STRUCTURE: 500 WALNUT STREET
 LOCATION: 500 WALNUT STREET PHILADELPHIA, PA 19106
 ARCHITECT: CECIL BAKER + PARTNERS
 ENGINEER: WSP GROUP
 CUSTOMER: ---

MADE BY: ST DATE: 10/14/2015 CONTRACT NUMBER: ---
 DRAWING COVERS: THIRD FLOOR SLAB (BOTTOM LONG WAY REINFORCEMENT) DRAWING NUMBER: R61

DRAWING COVERS: THIRD FLOOR SLAB (BOTTOM ADDITIONAL & LINK BEAM) DRAWING NUMBER: R63

DRAWING COVERS: THIRD FLOOR SLAB (TOP ADDITIONAL Y-DIRECTION & LINK BEAM) DRAWING NUMBER: R64

3RD FLOOR FRAMING PLAN
 (SHOWING 13TH CONC. SLAB BOT LK REINFORCEMENT DETAILS)
 SDR:5-0305-0315-032 & 5-034

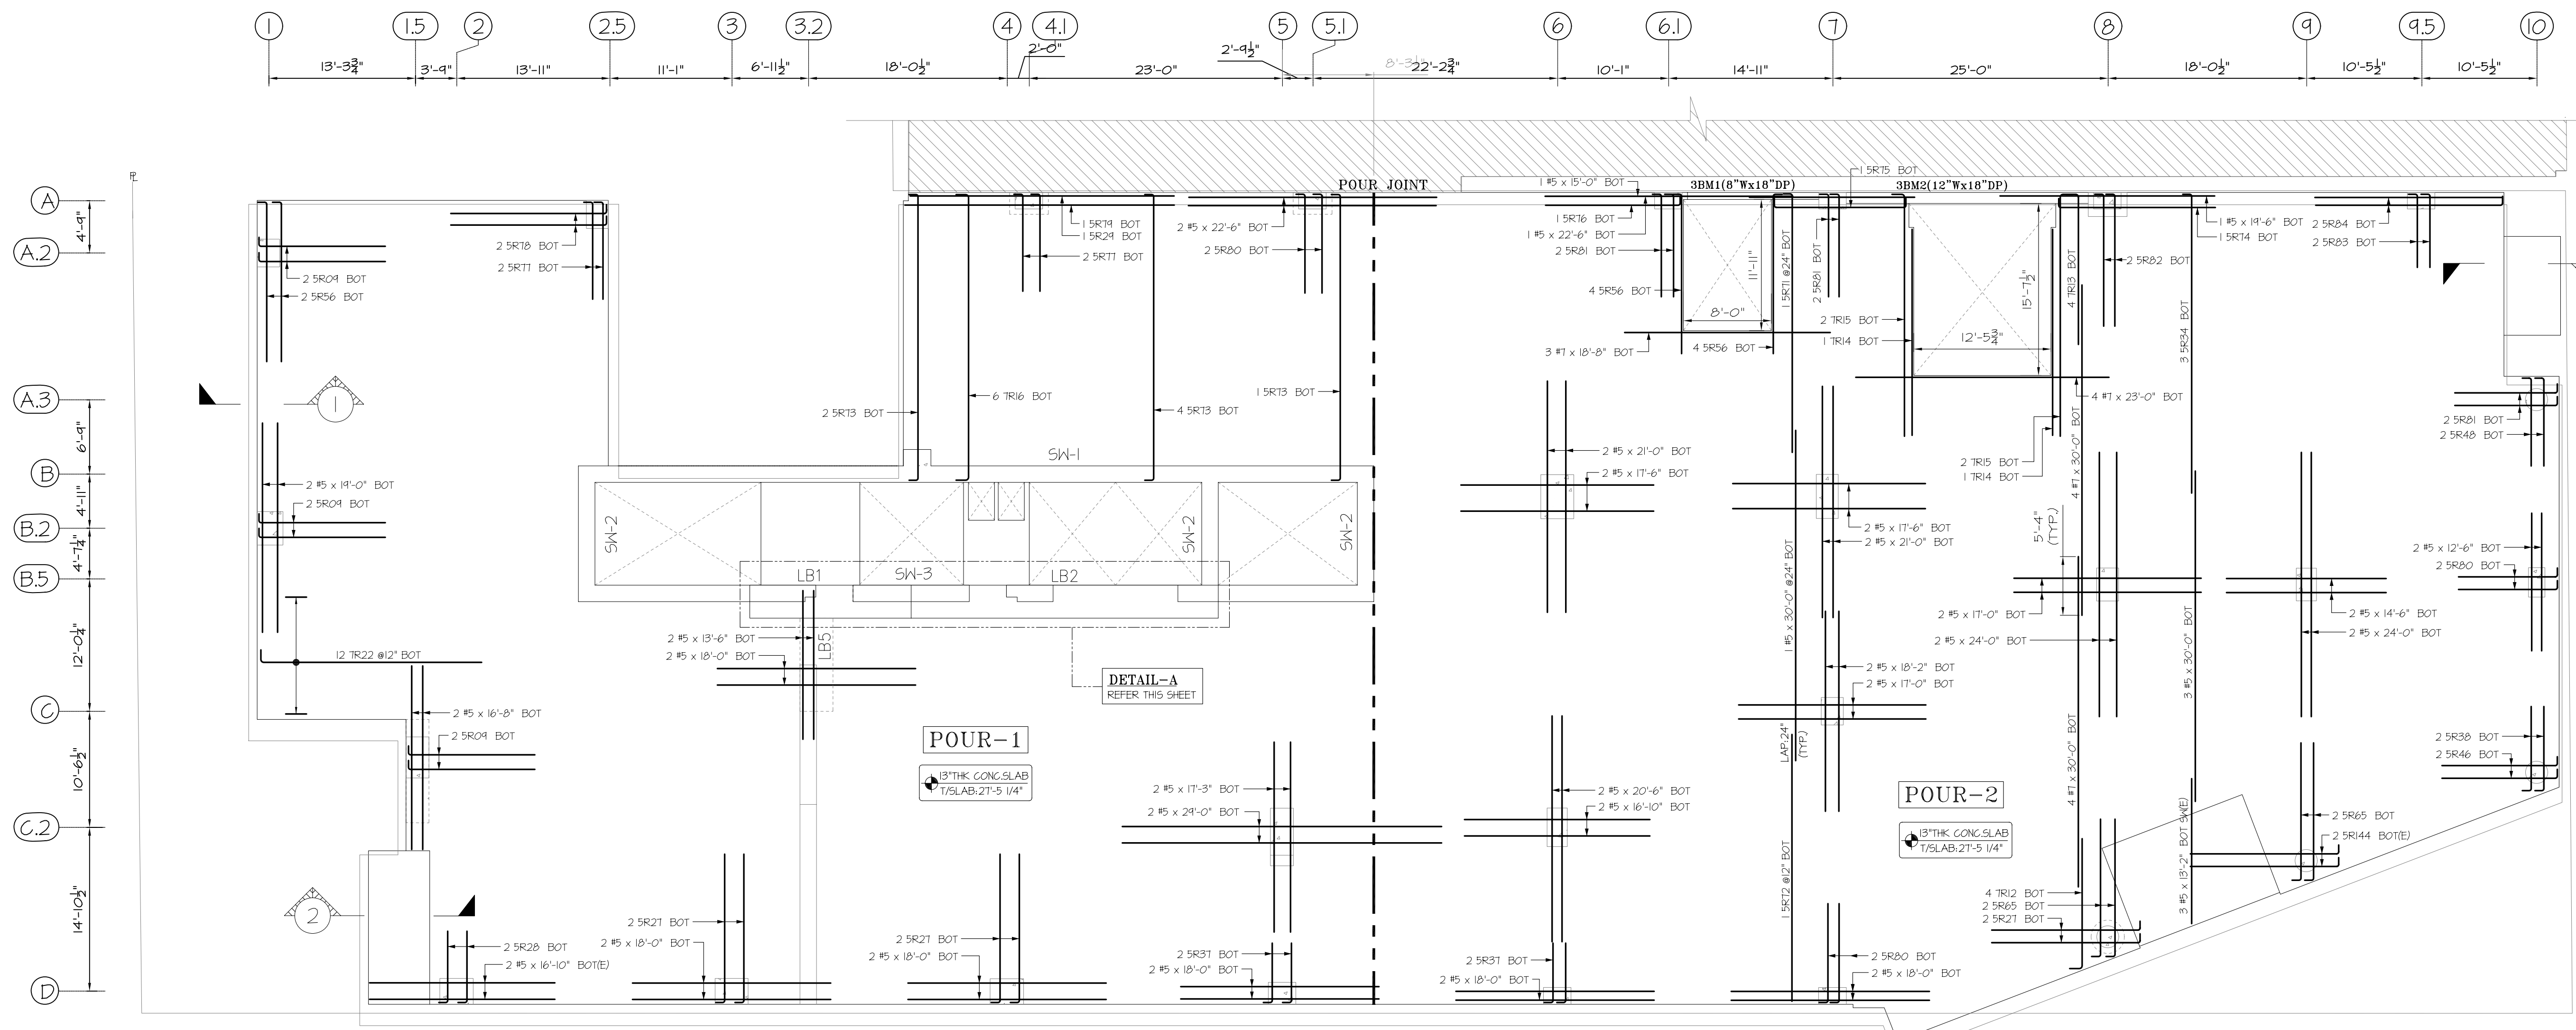
A/E TO VERIFY
 PLEASE REVIEW & CONFIRM, ALL CLOUD LAP VALUE. WE FOLLOWED LAP TABLE IN STR. SHEET, S-965 AS PER TABLE #1 : 1.A (3/4" COVER) 6000 PSI

DETAIL-A
 SHOWING LB1&LB2 REINFORCEMENT DETAILS

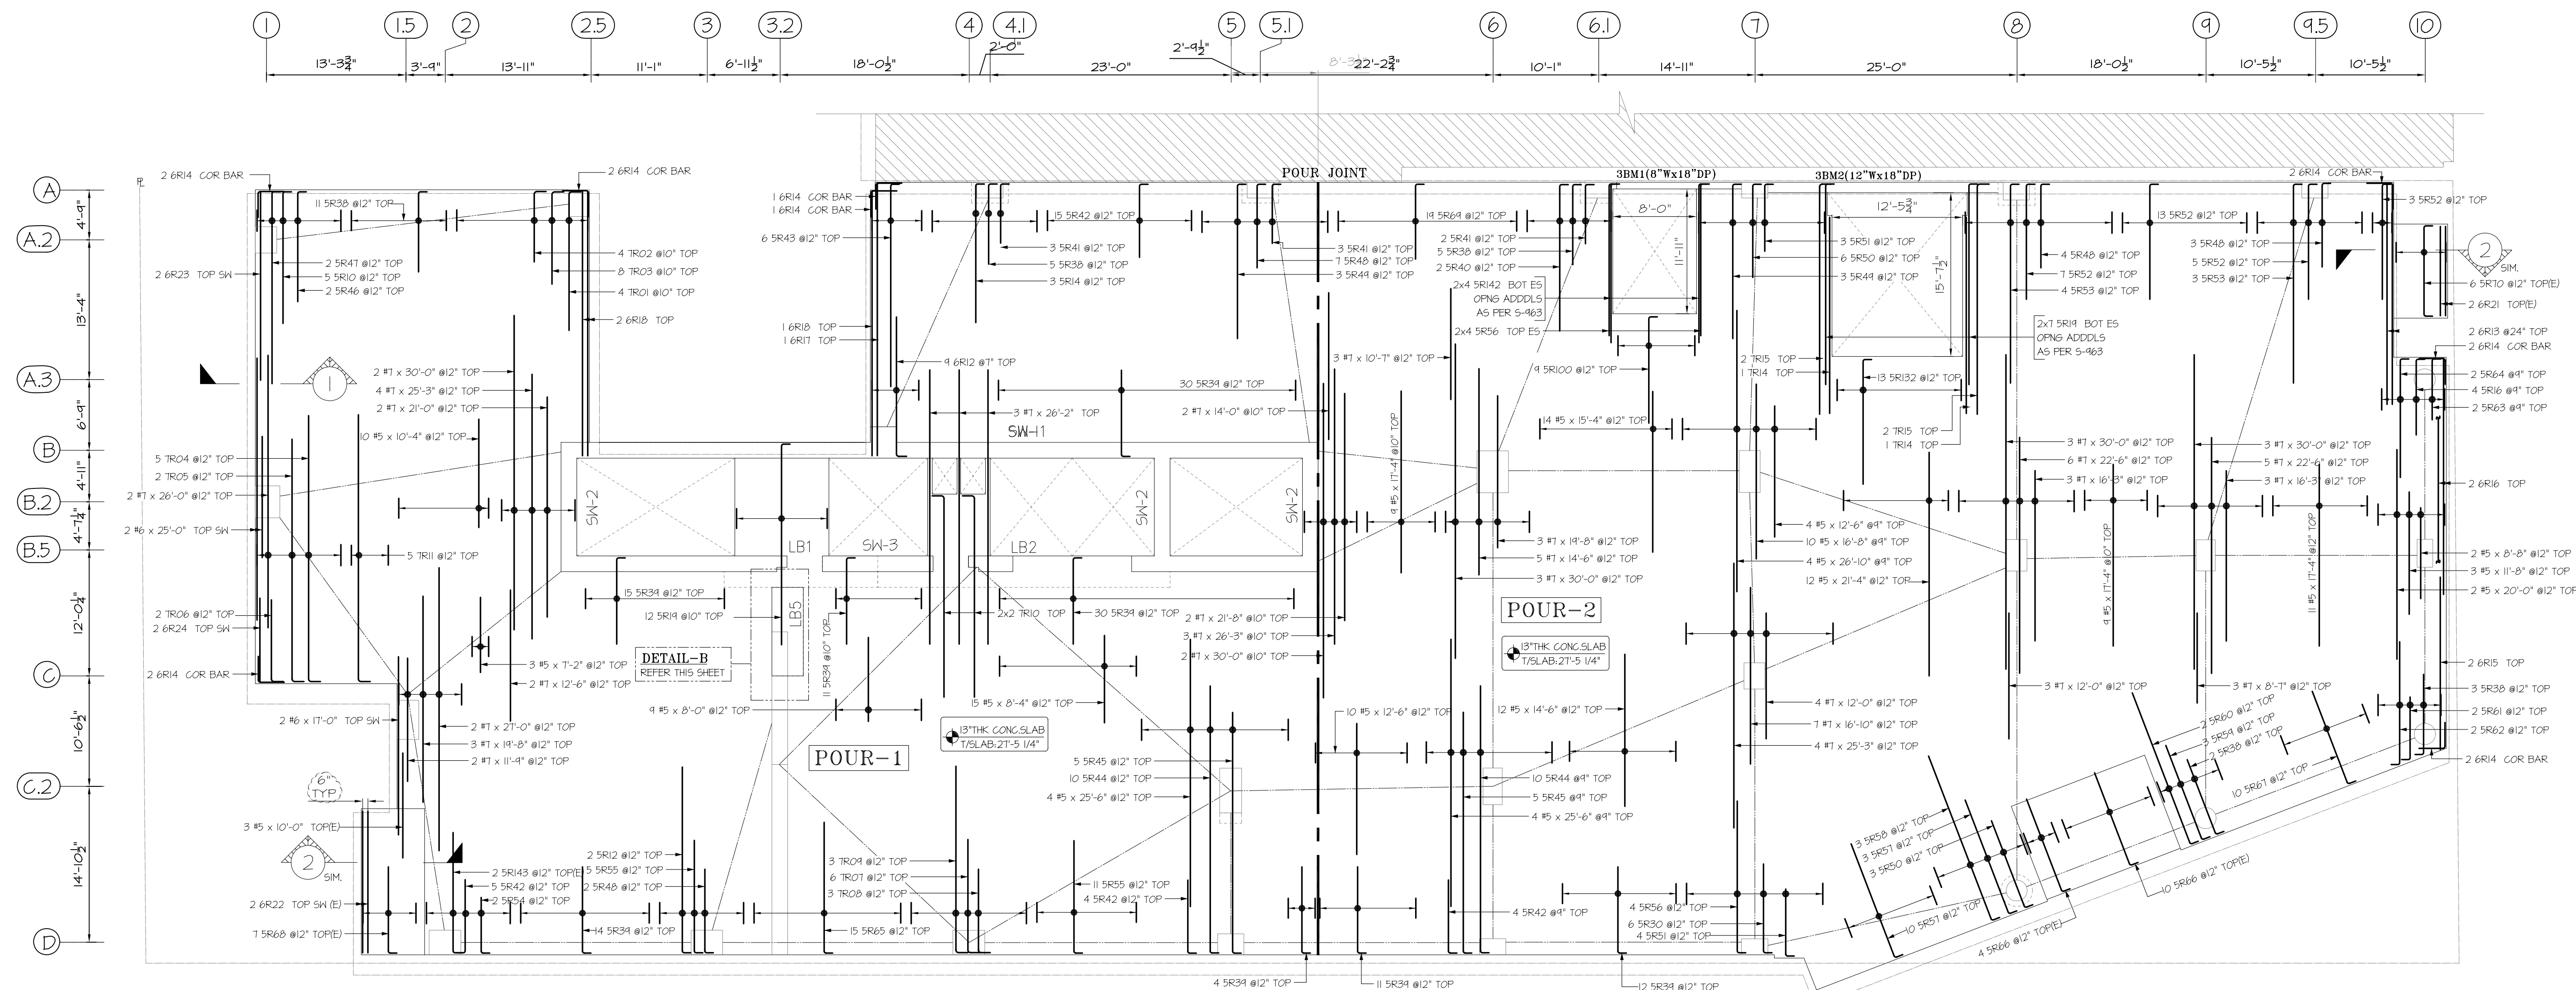
PLEASE REVIEW & CONFIRM, ALL CLOUDED LAP VALUE. WE FOLLOWED LAP TABLE IN STR SHEET: S-965

3RD FLOOR FRAMING PLAN
 (SHOWING 13" THK SLAB TOP (Y-DIR) REINFORCEMENT DETAILS)
 SDR:5-030-5-031-5-032 & 5-034

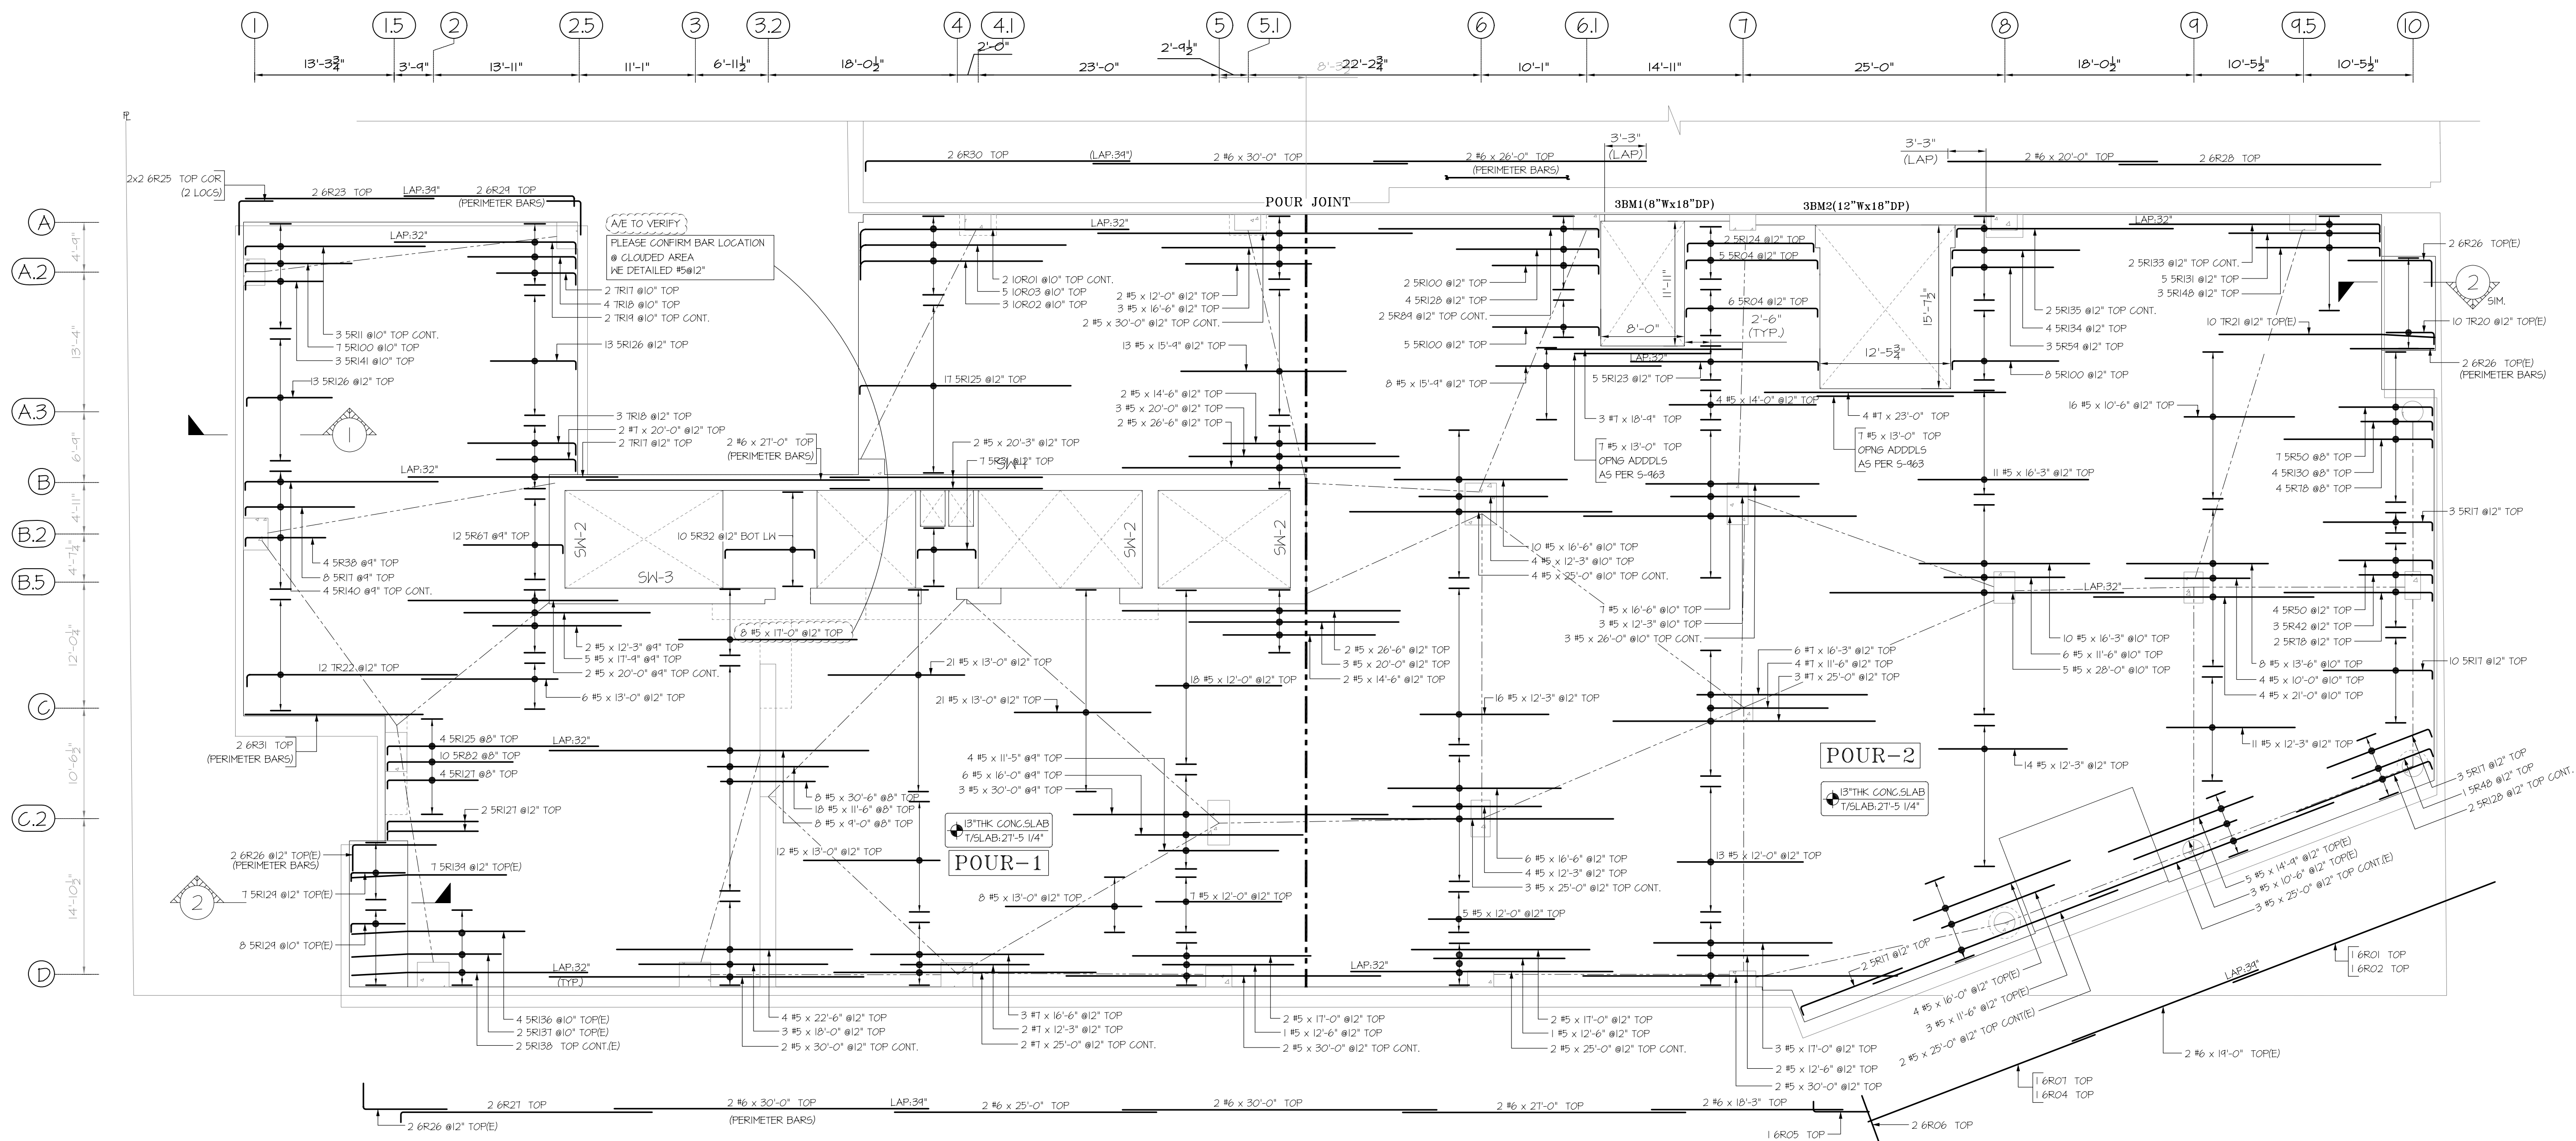
PLEASE REVIEW & CONFIRM, ALL CLOUDED LAP VALUE. WE FOLLOWED LAP TABLE IN STR SHEET: S-965

3RD FLOOR FRAMING PLAN
 (SHOWING 13" THK. SLAB TOP (X-DIR.) REINFORCEMENT DETAILS)
 SDR:5-0305-0315-032 & 5-034

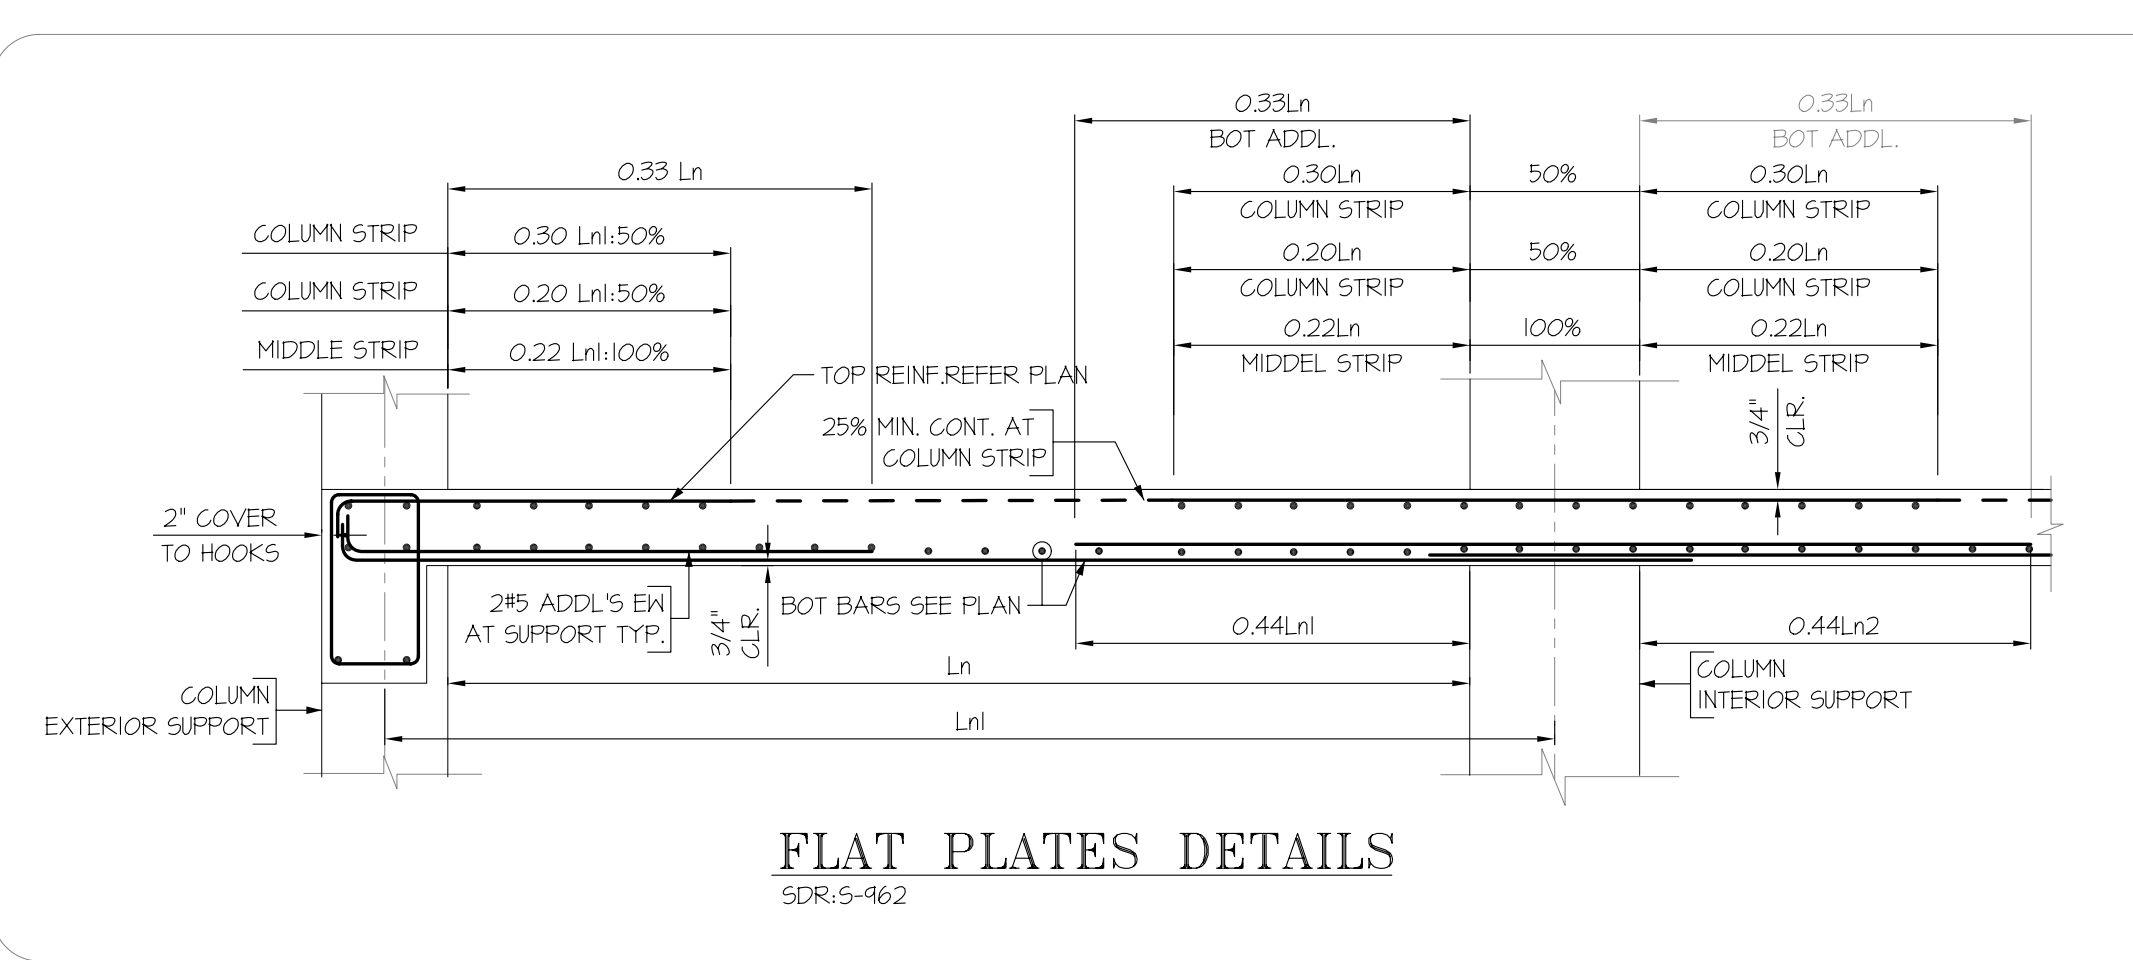
A/E TO VERIFY
 PLEASE REVIEW & CONFIRM, ALL CLOUDED LAP VALUE. WE FOLLOWED LAP TABLE IN STR SHEET, S-965 AS PER TABLE #1 : 1.A (3/4" COVER) 6000 PSI
